RIVER HEIGHTS CITY PLANNING COMMISSION AGENDA

River Heights City Planning Commission
Minutes of the Meeting
May 3, 2017

**RE: Saddlerock Subdivision Phase 3
Plat and Const. Plan Review – 2nd Iteration**

STREET AND STORM SEWER PLAN
SADDLEROCK - PHASE 3
 RIVER HEIGHTS, UTAH

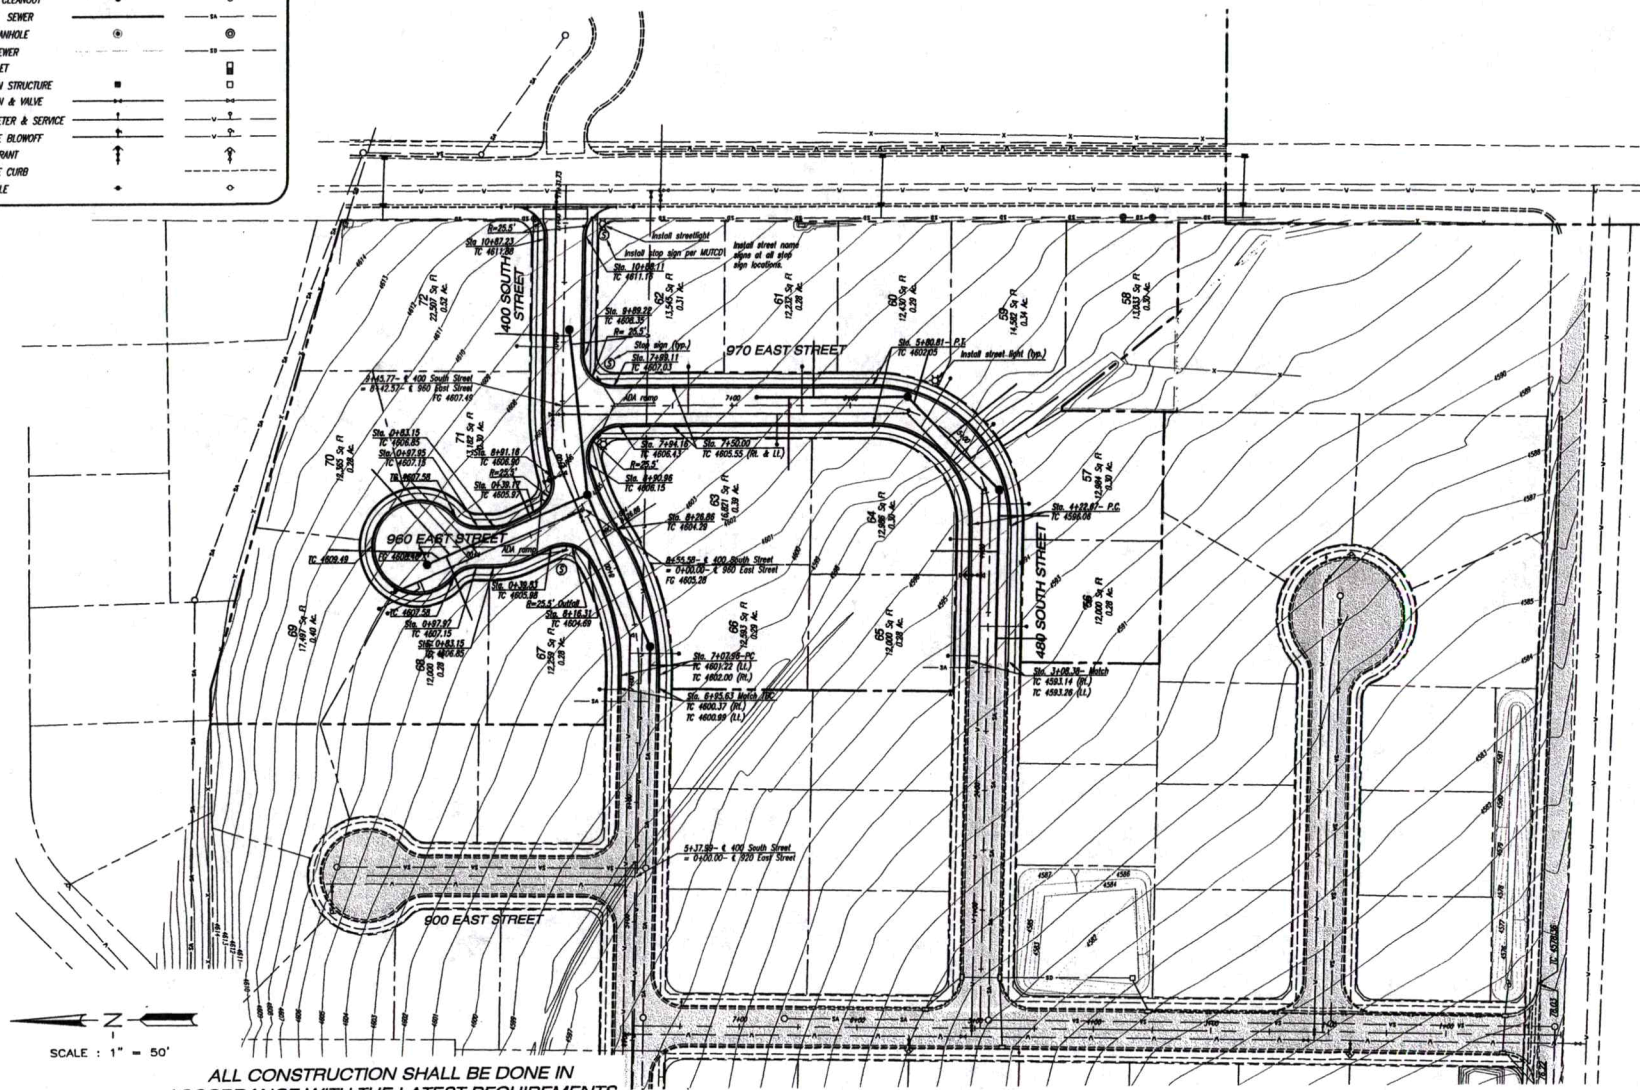
11. Sidewalk along the west side of 1000 East is required as per the approved preliminary plat, ADA ramps are required at the intersection of 400 South and 1000 East.

12. The previous review did not address fencing along 1000 East. The fencing should be consistent across the lots fronting 1000 East. Whereas there is an existing electrical switch gear box above grade on Lot 61, it is expected that the fence will need to jog around the switch box. Rocky Mountain Power should be consulted with respect to the required clearance around the vault.

13. Show applicable roadway section for 1000 East sidewalk with existing curb and gutter on the roadway section sheets with reference to sidewalk elevation.

14. Add street names to existing streets.
15. Access to Lot 58 should be 25 feet minimum into the lot as per the preliminary plat, adjust as necessary. The lot boundary shown at Lot 58 does not match the plat. Review all sheets for lot lines at this lot, as there are discrepancies throughout and as it does not appear that ownership of triangle pieces that may be part of land exchanges has been ascertained or confirmed on the plat and construction plans.

16. Verify design and adjust the Right side Top Back Curb elevation on 400 S. at Station 7+07.96. The TBC elevation changes 1.63 feet vertical in 12.33 feet horizontal as shown on the plan. Provide a more smooth transition from the existing to proposed grades.

17. Verify/adjust the high point location/elevation on the west side of 970 East at 400 South. Sta. 7+94.16 TC elevation 4606.43. With this high point, stormwater would need to flow crosswise to the street cross section from this point to the next curb elevation on 400 South.

18. Intersection of 960 East and 400 South. Suggest calling out spill gutter at the northeast corner of this intersection to prevent ponding in the gutter.

19. The revised plan appears to improve the grading at intersections. Suggest adjusting grades at the east side of the 970 East 400 South intersection to bring the 970 E curb at Sta. 7+99.11 to elevation 4607.42 to provide a uniform 3.73% slope around the radius and to the end of the pavement cross slope transition point. Adjust as applicable on the street profile sheet.
